# Work Order ID 97423

Item Name: Crosstube Fwd

DRAWING NO. D206-667-143	TITLE CROSSTUBE ASS'Y (206L HIGH FWD)	REV. C	<b>DART AEROSPACE LTD ENGINEERING ORDER</b>		D.E.O. NO. D206-667-143-C-1	SHEET NO. SHEET 1 OF 1	SCALE NTS
DRAWN <i>97</i>	CHECKED <i>ASS</i>	MFG. APPR. <i>128</i>	APPROVED <i>MD</i>	DE APPR. <i>#</i>			
DATE 11.07.15	DATE 11.07.20	DATE 11.07.21	DATE 11/07/21	DATE 11.07.21

DRAWING NO. D206-667-143		TITLE CROSSTUBE ASS'Y (206L HIGH FWD)		REV. C DART AEROSPACE LTD ENGINEERING ORDER		D.E.O. NO. D206-667-143-C-2		SHEET NO. SHEET 1 OF 1		SCALE NTS	
DRAWN AJS		CHECKED J		MFG. APPR. B		APPROVED AP		DE APPR. H			
DATE 12.08.02		DATE 12.08.02		DATE 12.08.02		DATE 12.08.02		DATE 12-08-02

DEO ATTACHED RELEASED  
08/11/12

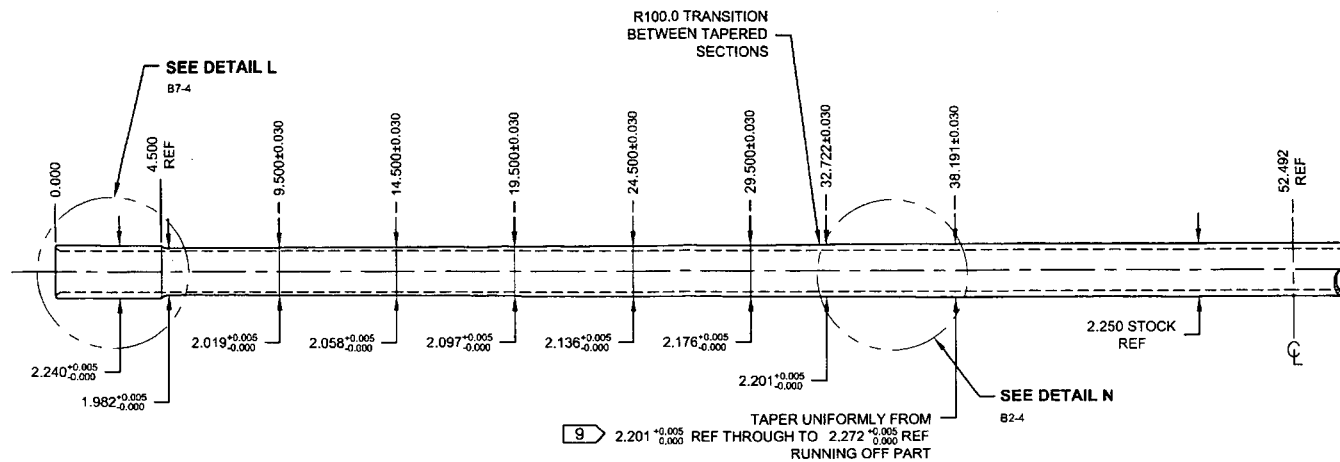
C	REVISE GENERAL NOTES/PART LIST (ZN D7-1); REORGANIZED VIEWS AND REFORMATTED DRAWING TO CURRENT STANDARDS. D3595-063-395 WAS D2855-400-694 (ZN D6-2 & A5-2); REMOVED REF. & ADD TOLERANCE (ZN D3-3, C4-3, C5-3); RELOCATED FLAG #6 (ZN A8-3) PER NCR 210; MOVED TURNING DETAIL & UPDATED TOLERANCE TO SHEET 4.	RF	08.11.06
B	ADD HOLES AND NUT PLATES FOR COMPATABILITY WITH BHT/AA SKUDTUBES	PH	05.07.26
A	NEW ISSUE	CP	00.11.17
REV.	DESCRIPTION	BY	DATE
DESIGN	97	DART AEROSPACE LTD	
DRAWN	RF	HAWKESBURY, ONTARIO, CANADA	
CHECKED	97	DRAWING NO.	REV. C
MFG. APPR.	97	D206-667-143	SHEET 1 OF 4
APPROVED	97	TITLE	SCALE
DE APPR.	97	CROSSTUBE ASSY (206L HIGH FWD)	NTS
DATE	08.11.06	COPYRIGHT © 2000 BY DART AEROSPACE LTD THIS DOCUMENT IS PRIVATE AND CONFIDENTIAL AND IS SUPPLIED ON THE EXPRESS CONDITION THAT IT IS NOT TO BE USED FOR ANY PURPOSE OR COPIED OR COMMUNICATED TO ANY OTHER PERSON WITHOUT WRITTEN PERMISSION FROM DART AEROSPACE LTD.

**DETAIL P**  
BONDING STRAP INSTALLATION 2 PL

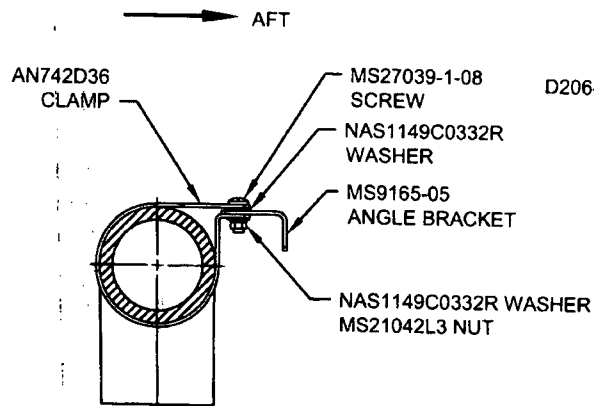
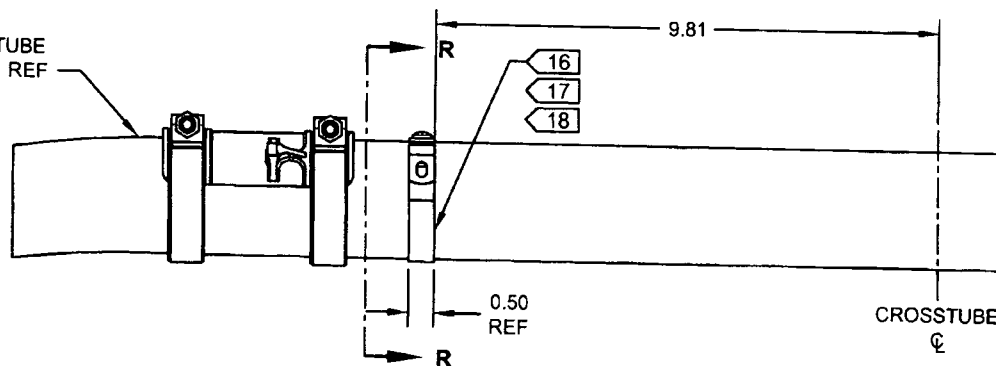
ADD ELECTRICAL GROUNDING STRAP

ADD

ITEM	QTY -143	PART NUMBER	DESCRIPTION
1	X	D206-667-143	CROSSTUBE ASSEMBLY (206L HIGH FWD)
10	2	AN742D36	CLAMP
11	2	MS9165-05	ANGLE BRACKET
12	2	MS21042L3	NUT (OR MS21042-3)
13	2	MS27039-1-08	SCREW
14	4	NAS1149C0332R	WASHER (OR AN960C10L)
